MAS003432 RU 23-01

Rapid Update 590 Maserati MC20: Door noise

DATE: MARCH 10 2023

Figures 2 Pn swabs: 670293545

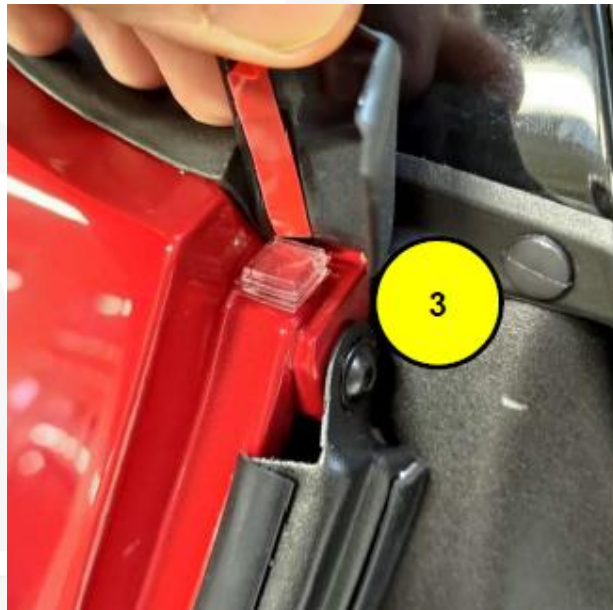
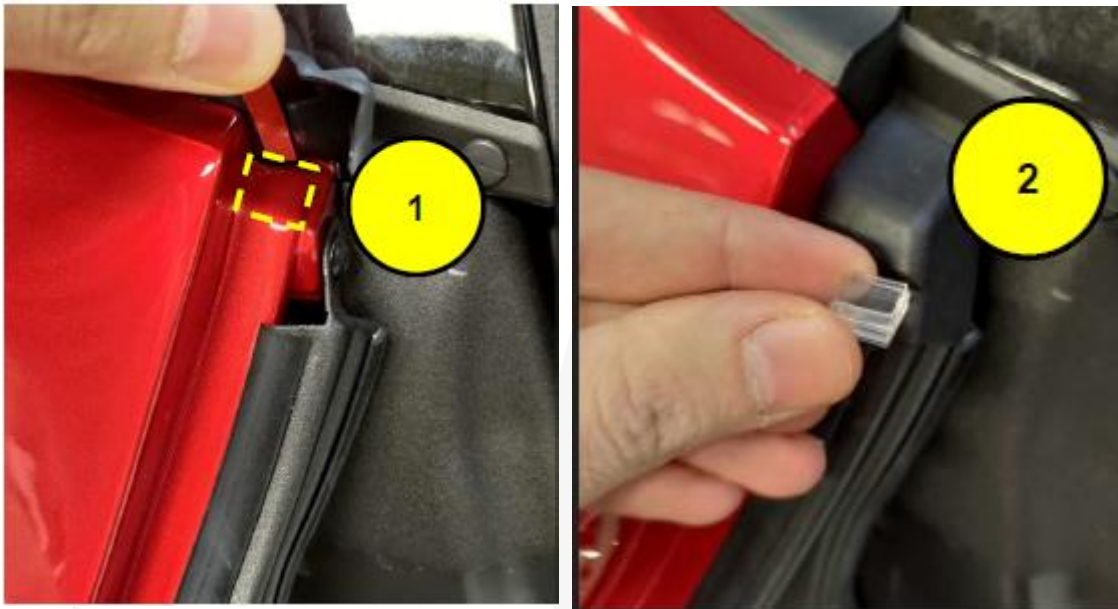
- At this point, use the p/n code 670293545 in quantity 2 (figure 1).
- Clean the surface of the pads with heptane or similar using a paper cloth, taking care to eliminate any residual contaminants from the surface and overlap them, eliminating the protection of the double-sided adhesive filler from one of the two (figure 2)

Figures 1: Overlapping and glued pads

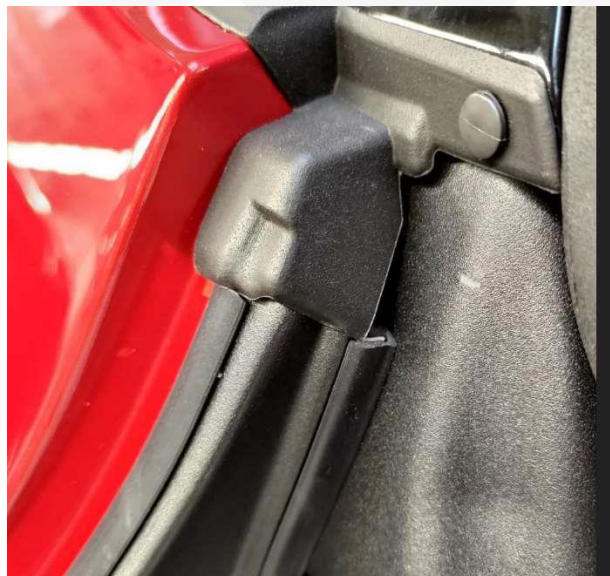
- Once the area (1) on the car has been identified, take the previously prepared rubber pads (2) and remove the protection of the double-sided adhesive filler from the lower rubber pad and apply it on the fender (3) by exerting firm pressure.
